# UNITED STATES PATENT AND TRADEMARK OFFICE

APPLICATION NO.	FILING DATE	FIRST NAMED INVENTOR	ATTORNEY DOCKET NO.	CONFIRMATION NO.
10/587,497	07/20/2007	Stanton R. Canter	2184P002US	8330

<b>Office Action Summary</b>	<b>Application No.</b> 10/587,497	<b>Applicant(s)</b> CANTER, STANTON R.	
	<b>Examiner</b> Edward Moran	<b>Art Unit</b> 3732

## **DETAILED ACTION**

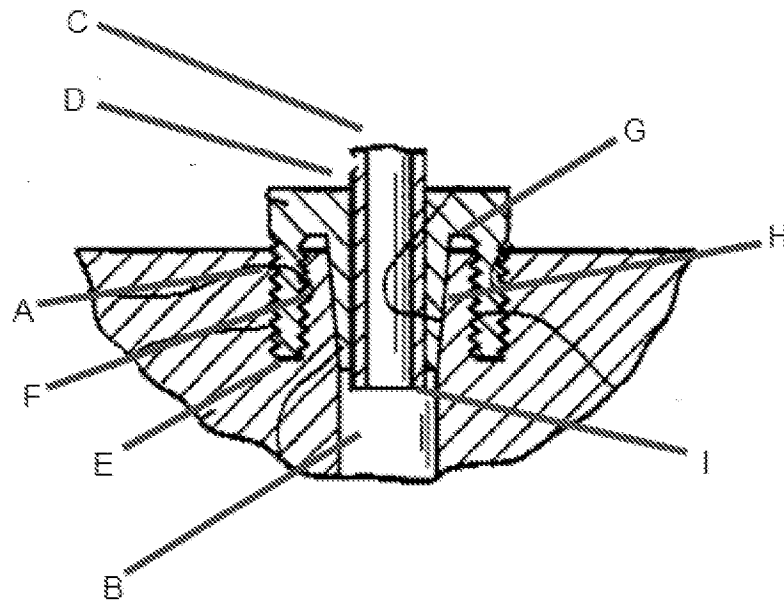
7. Regarding claims 1, 4, 6-7, 11-12 and 14-16, Simmons teaches an anchoring element (Figs. 3-17) capable of use in bone and capable of placement in a prepared molar socket that includes interradicular bone, comprising; a first surface (e.g. first means; A, see figure below) having a distal end (B) and a proximal end (C), with at least a portion including a first external thread having a pitch (see A on Figure Below), capable of threadedly engaging an outer wall of a molar socket; an abutment surface (e.g. abutment means; D) disposed at a 90 degree angle to an axis from the proximal end to the distal end of the first surface, and towards the proximal end of the first surface, capable of receiving a dental prosthesis, for example with an adhesive; an annular second surface (e.g. second means; E, bottom of device) disposed toward the distal end of the first surface and joined to the first surface along an outer circumference

of the second surface, capable of bearing against a bottom surface of a molar socket; a third surface (e.g. third means; F) concentric with the first surface and joined to the second surface along an inner circumference of the second surface, at least a portion of the third surface including an internal thread having the pitch of the first external thread (e.g. synchronized threads, see column 8, line 55 through column 9, line 15) capable of threadedly engaging a first surface and further compressing an interradicular bone that generally faces the outer wall of a molar socket; and a fourth surface (G) disposed between the distal end and the proximal end of the first surface and joined to the third surface along an outer circumference of the fourth surface (see column 6, line 55 through column 7, line 38). It is noted that the anchoring elements of Simmons could easily be screwed into the jaw bone and are capable of performing the functional or operative language claimed. Further, since the threads of the first and third surfaces are synchronized (e.g. same starting location, pitch, length, width etc), it is inherent that both threads are capable of advancing the anchoring element at the same rate when the anchoring element is rotated to embed it into bone.

8. Simmons further teaches that the fourth surface (G) is annular and the element further comprises a fifth surface (H), capable of bearing against and compressing a side wall of a hole prepared in an interradicular bone, and concentric with the first surface and joined to the fourth surface along an inner circumference of the fourth surface and including a frustrated third conical portion adjacent the distal end such that a smaller circumference of the third conical portion is adjacent the distal end (see Figure Below);

and a sixth surface (I) disposed toward the distal end of the first surface and joined to the fifth surface along an outer circumference of the sixth surface.
